Quality Control Report

Consultant Site Name Package Contractor Tender No.	Wahib Medanat Consultant Engineers Khadija Bint Khwailed Basic Mixed - Balqa Package 1 Derar Saraireh & Sons for Engineering & Contracting 1/2020/USAID/SKEP/3/1		Rep No. Date	QC-13 11 10 / 11 / 2021
Description of Non Conformance		Corrective Action	Required by / When	
 Door frames are not protected. Dimensions of sills are not complying. Installing electrical outlets at elevations is wrong. Executing expansion joint wrongly. 		 To be cleaned and protected by nylon or appropriate sheets. To be replaced. To be rectified. To be rectified. 	The Contractor/Immediately	
Report Prepared by		Hassan Shaqbua, Supervision Quality Control Manager		
Contra	ictor's Response			
No response by The Contractor.

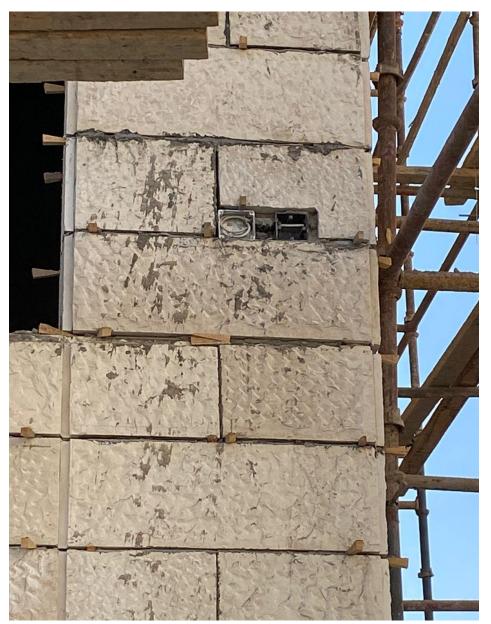
Dimensions of sills are not complying

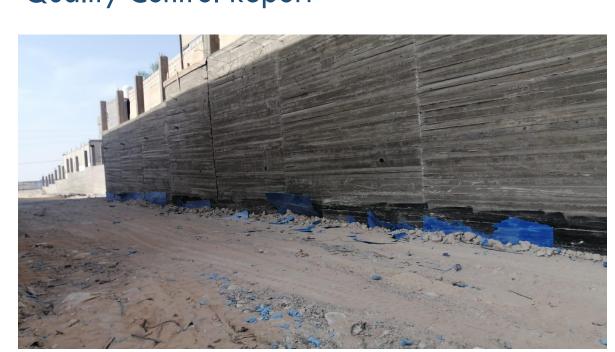
Executing expansion joint wrongly

process to re-excute the expantion joint
